SERVICE BULLETIN

NUMBER: M20-206

CONVERSION OF LYCOMING IO-360-A1B6D TO IO-360-A3B6D

M20J - 24-0002 thru 24-0377

Fig. 1: Propeller Flange Bushing Location For IO-360-A3B6D (Prop moves 60 degrees against rotation)

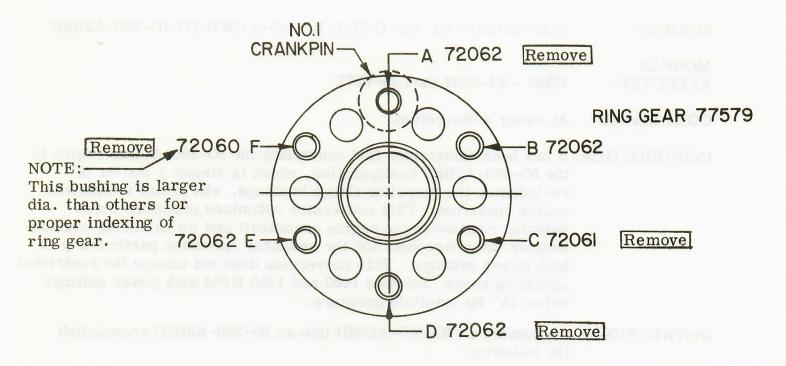
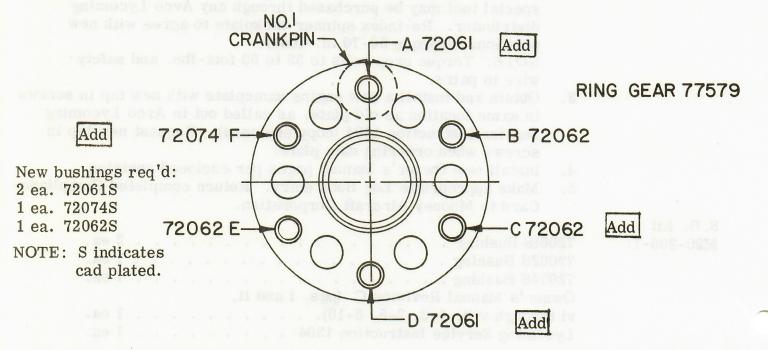
- 1. Remove four (4) of the original propeller flange bushings as indicated in Figure 1. NOTE: Do not re-use any of the bushings that are removed.
- Install new bushings using Avco Lycoming special tool part no. ST-115 in the locations shown in Figure 2. NOTE: The special tool may be purchased through any Ayco Lycoming distributor. Re-index spinner backplate to agree with new position. (Torque 50-70 in.-lbs.) NOTE: Torque prop bolts to 55 to 60 foot-lbs. and safety wire in pairs.
- Obtain and install a new engine nameplate with new tap in screws in same location as old plate, as called out in Avco Lycoming Service Instruction 1304 (copy enclosed). Request new tap in screws when ordering data plate.
- Install new Owner's Manual pages per enclosed revision. 4.
- Make appropriate Log Book entry. Return completed Compliance 5. Card to Mooney Aircraft Corporation.
